# City of Raleigh

## COA-0092-2019

### 213 E CABARRUS STREET

## APPLICATION FOR A CERTIFICATE OF APPROPRIATENESS – STAFF REPORT

① BUILT MASS & AREA DIAGRAM  
1" = 20'-0"

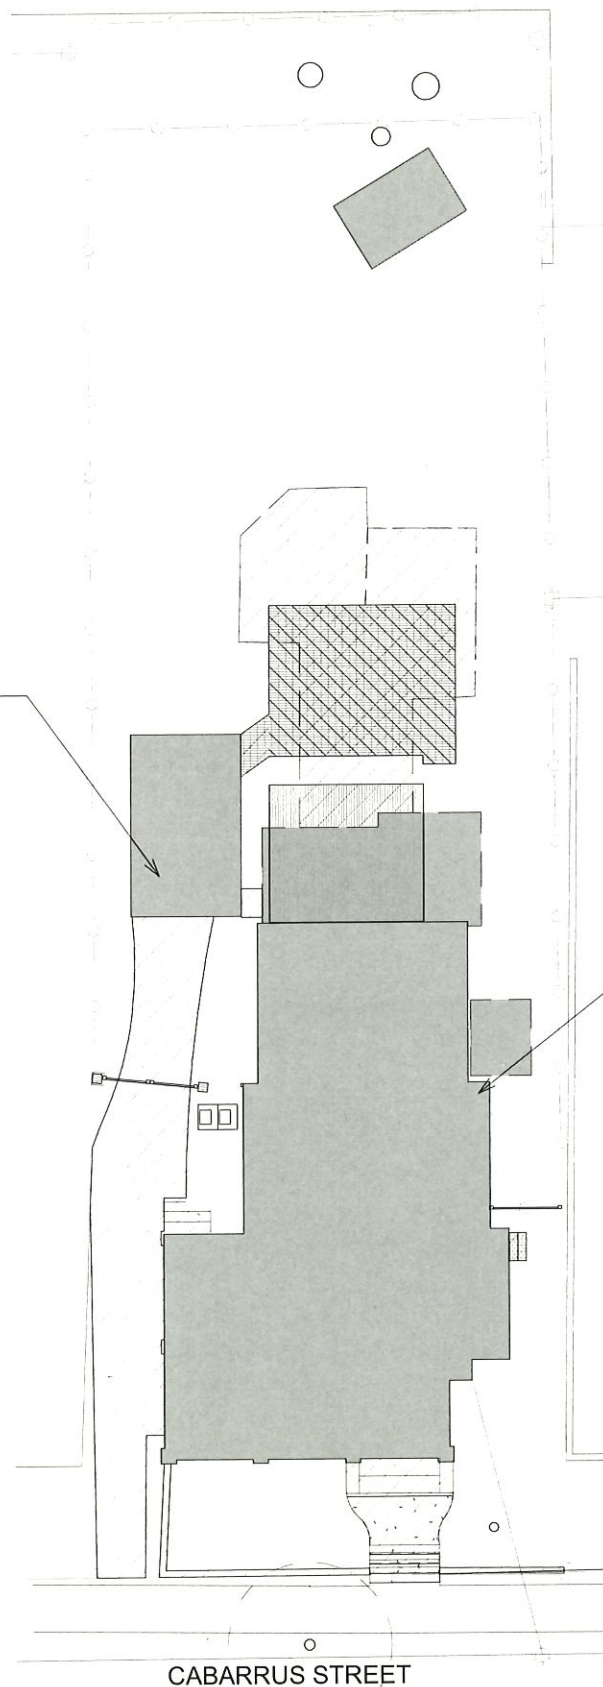
8\* The application includes the following built **area** to open space analysis: The lot is 8,101 SF. The existing built area is 3,457 SF, or 44%. The proposed built area is 2,940 SF, or 36%. This is a decrease in built area of 8%.

- 9\* The application includes the following built **mass** to open space analysis: The lot is 8,101 SF. The existing built mass is 2,242 SF, or 28%. The proposed built mass is 1,917 SF, or 24%. This is a decrease in built mass of 4%.

① PRIVACY FENCE DETAIL  
1/2" = 1'-0"

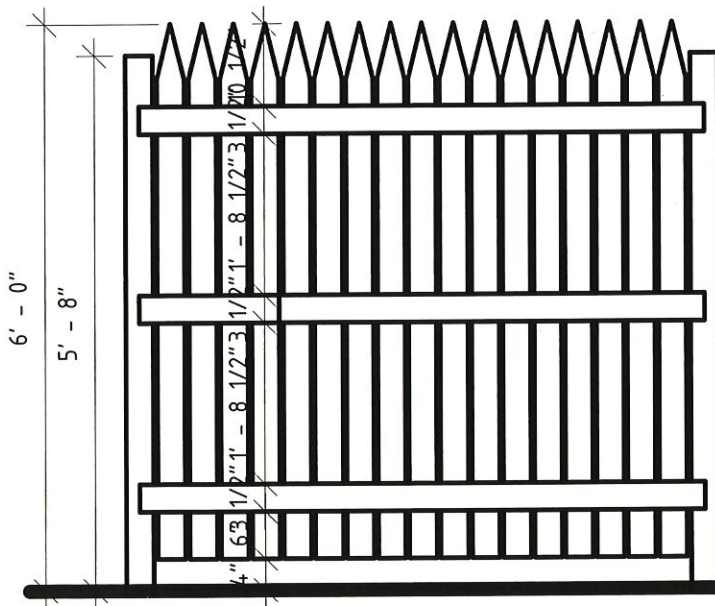
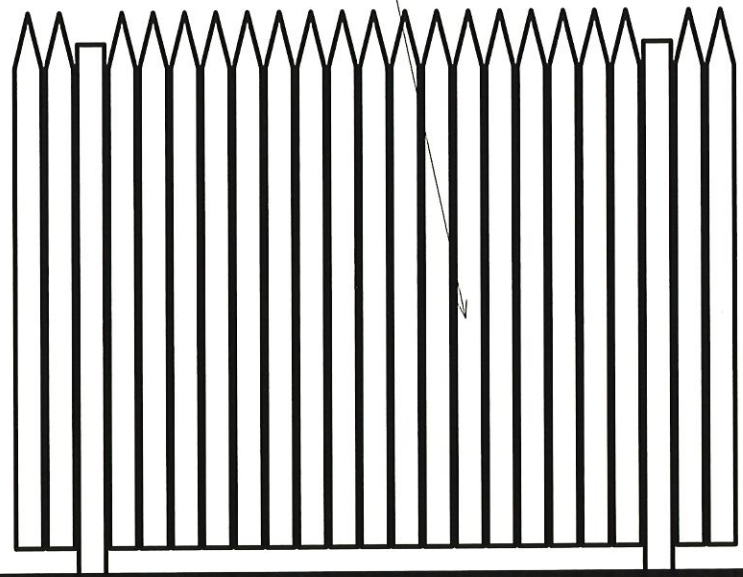
- 9\* The cast iron railings in the front yard and two brick pillars with lions are proposed to remain.
- 10\* A wood privacy fence is proposed to be installed on the north, east, and west property lines. This is a typical configuration for fencing. The proposed fence will be constructed in the traditional neighbor-friendly design, with structural members facing inward. Detailed drawings were provided.

1. That fence post holes be dug manually to avoid damaging tree roots, and that any roots greater than 1" in diameter be cut cleanly with a proper tool such as loppers.

② 42" GATE DETAIL  
1/2" = 1'-0"

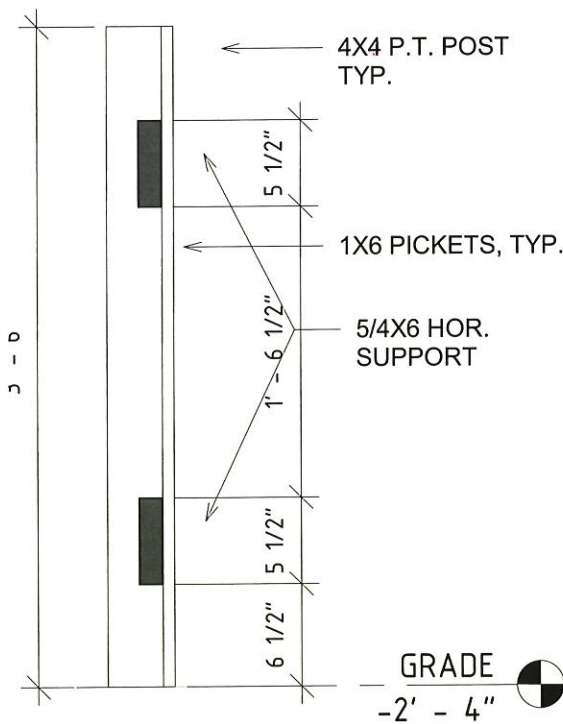
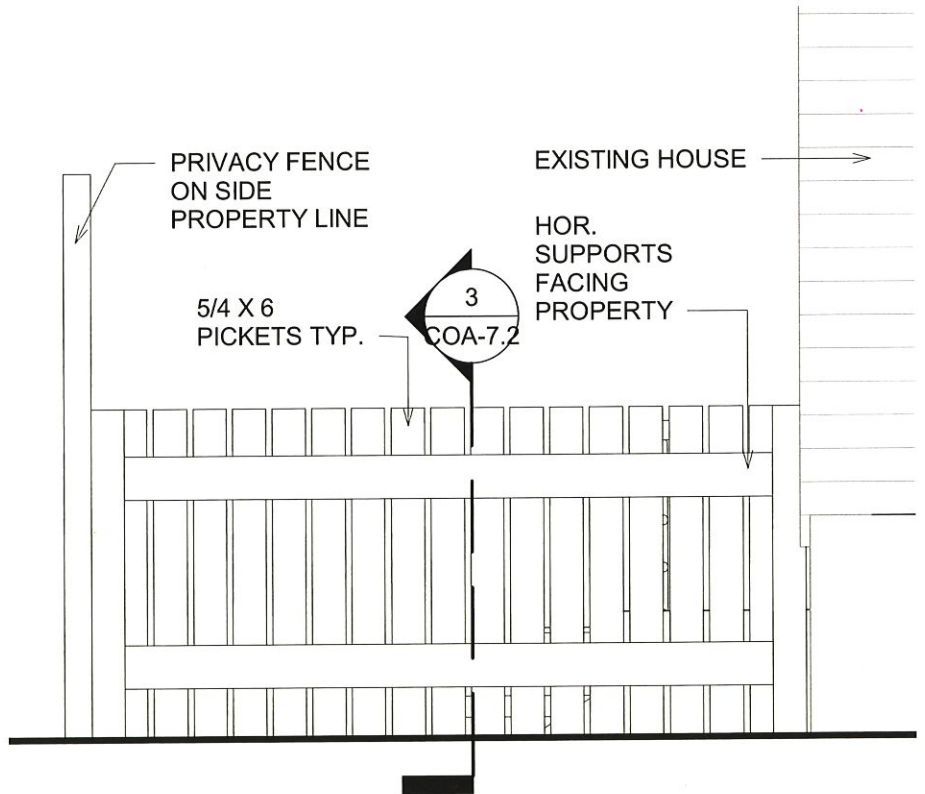
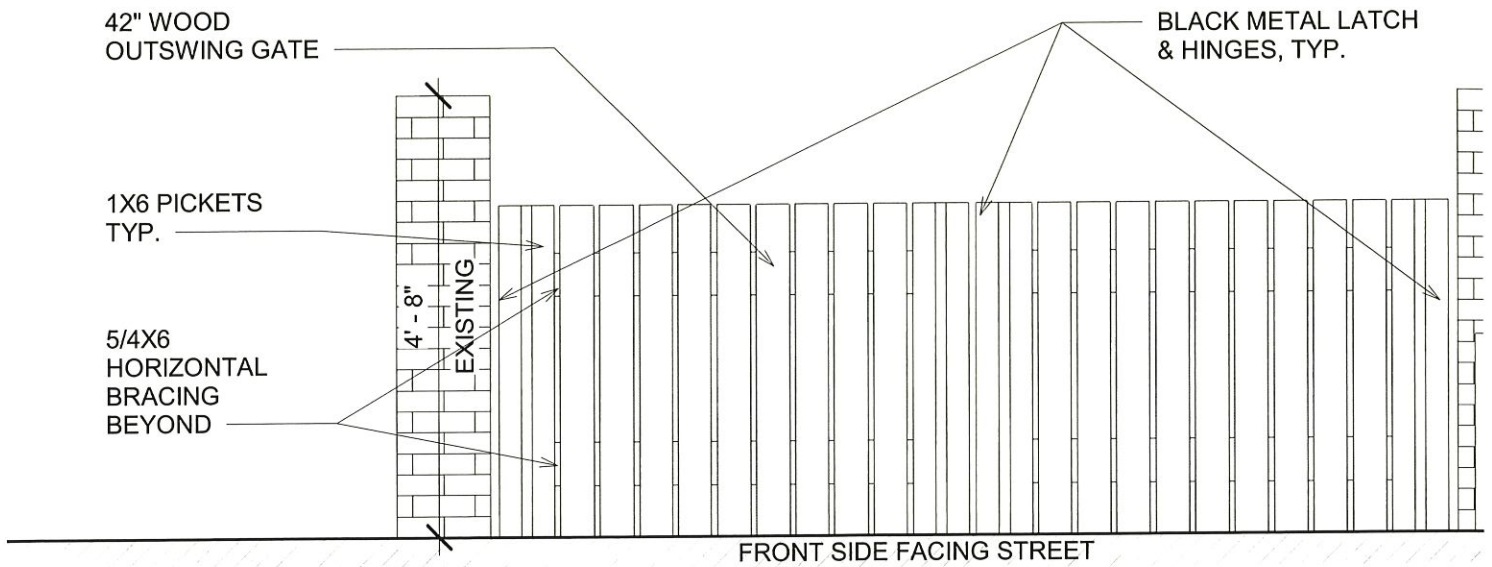
11\* An existing chain-link gate is proposed to be removed and replaced with a wooden gate.

Photographs of similar wooden gates in the district were provided. A drawing was provided.

12\* To the east of the house (from the street) an existing wood privacy fence is proposed to be replaced with a 42" wood picket fence. A drawing was provided.

## Section 5 - COLUMN & RAILING DETAIL

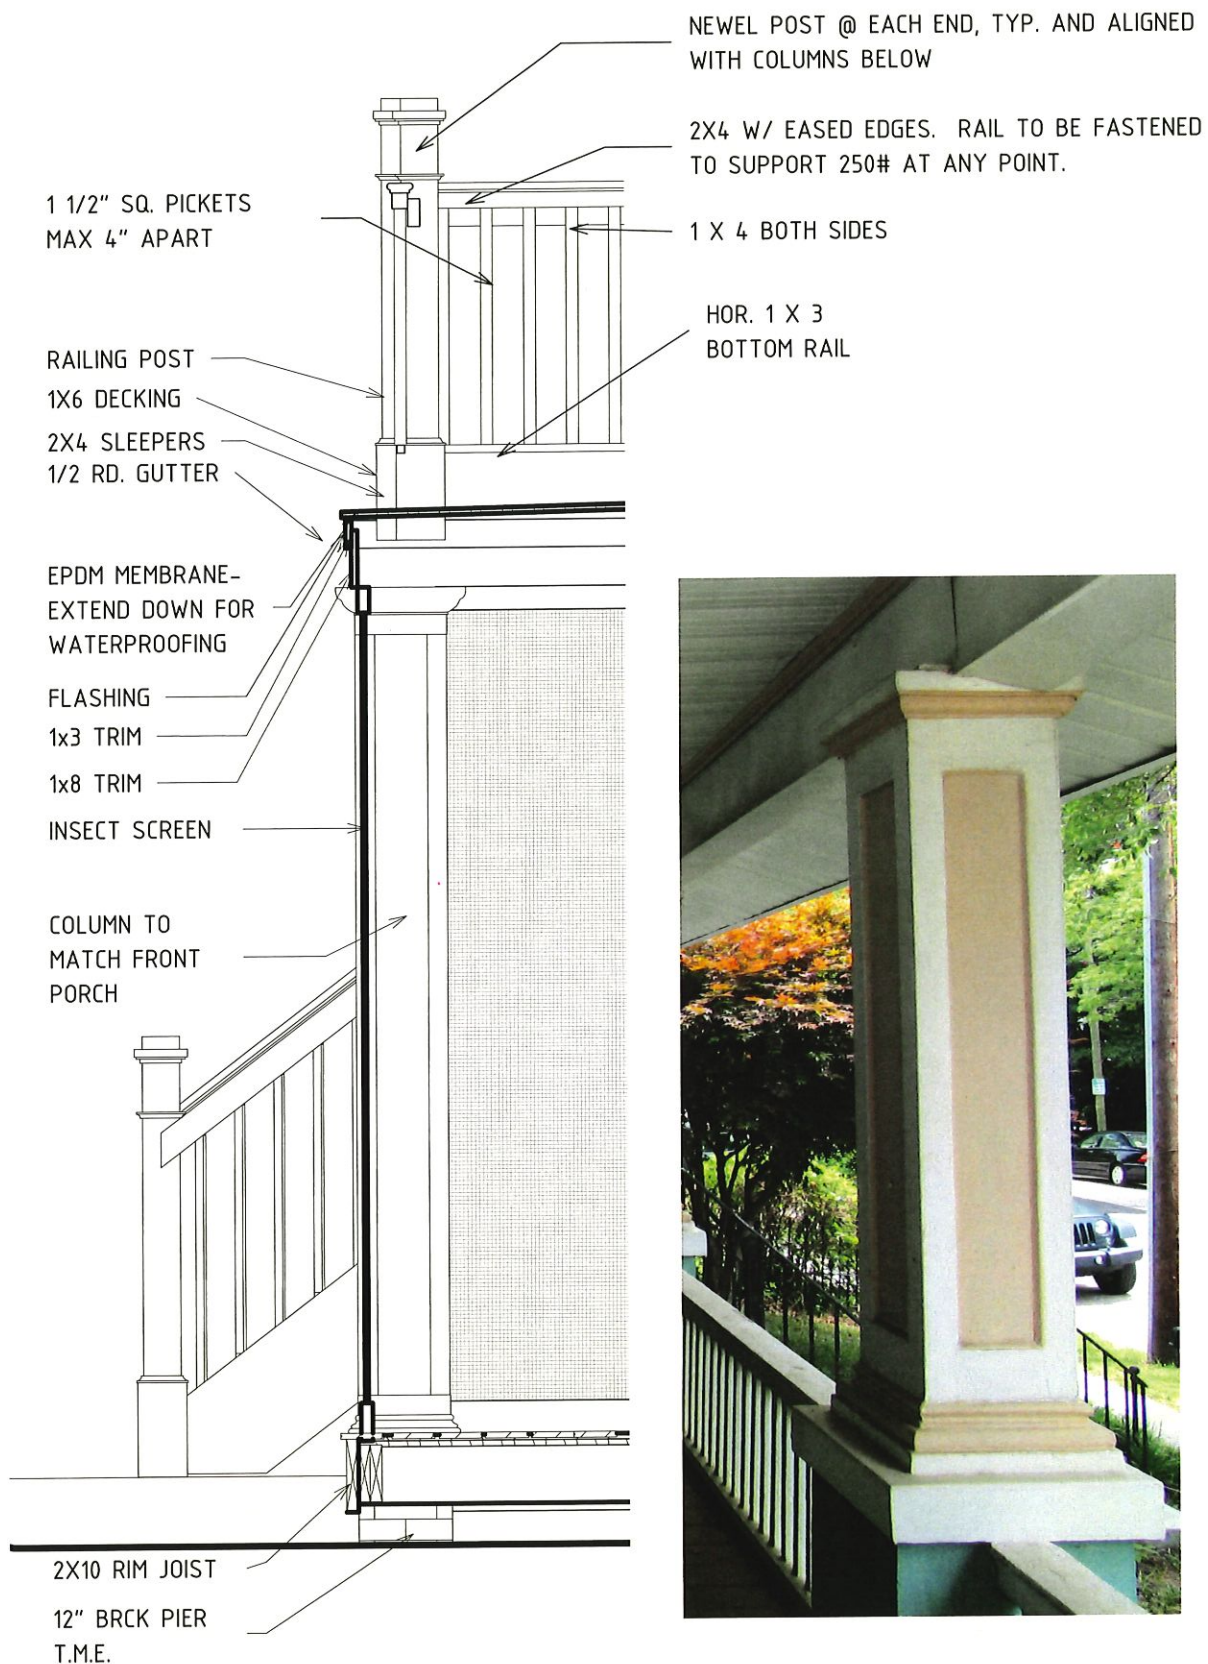
5\* The second-story deck railing is proposed to have the appearance of inset pickets; a drawing was provided.

7\* The Committee has previously required that screening be placed on the inside of railings and balusters so as to have a more traditional porch appearance. The drawings do not indicate that there will be railings and balusters around the screened porch. The application notes that the screening will be installed inside the columns. This is an atypical construction method for screened porches in the historic district. A drawing was provided.
